**Ontario Power Generation Inc.,
Pickering Nuclear Generating Station**

Request for a ten-year renewal of its Nuclear Power Reactor Operating Licence for the Pickering Nuclear Generating Station

Presentation to the Canadian Nuclear Safety Commission (CNSC)

OPG's Application re:

Pressure Tubes – Fracture Toughness

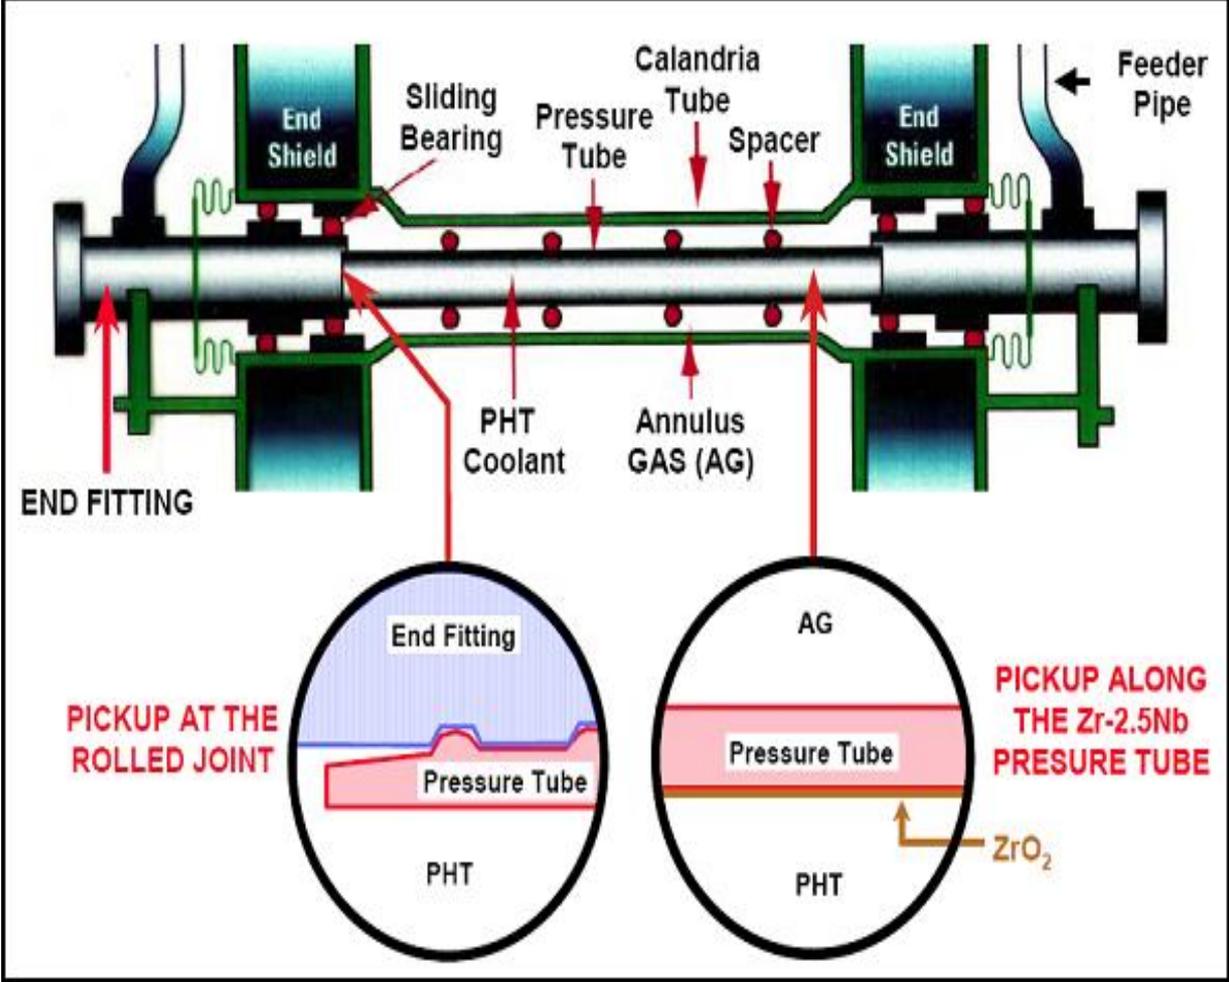
- **As reactors age, there is an increased risk for cracks to develop. If not detected or repaired (if that is even possible), this could lead to a Loss of Coolant Accident (LOCA) in the Heat Transport System (HTS).**
- **The concentration of hydrogen increases the longer the reactor operates. This accumulation of hydrogen results in the formation of blisters and cracks, and is the dominant contributor to the reduction in pressure tube fracture toughness.**

Deuterium Concentration Profile

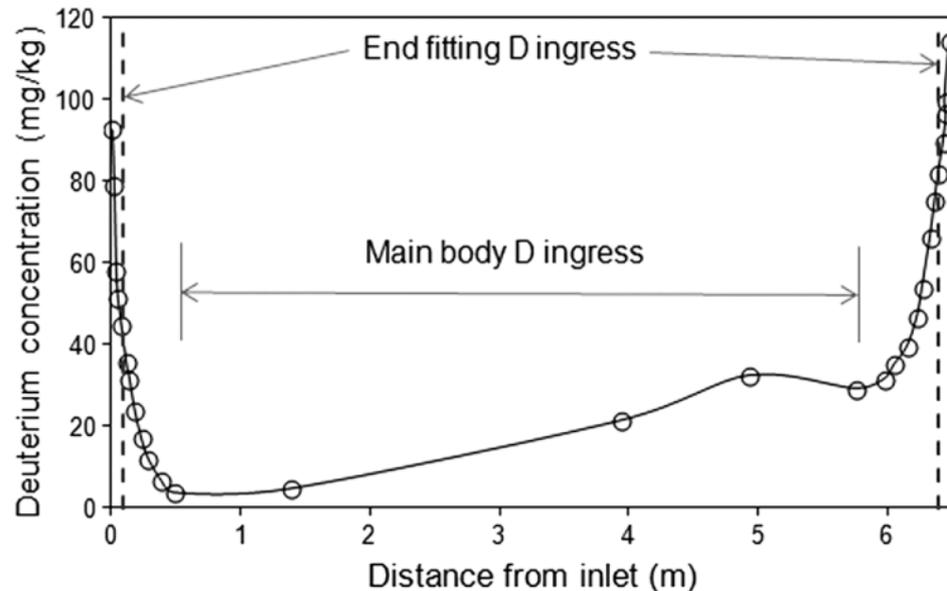
The following figure shows a typical deuterium profile (in mg/kg) along the axial length of a pressure tube after ~17 hot years of service.

The deuterium concentration increases along the main body of the pressure tube peaking near the outlet end. Approximately 2%–10% of the deuterium generated by the corrosion process is absorbed along the body of the tube.
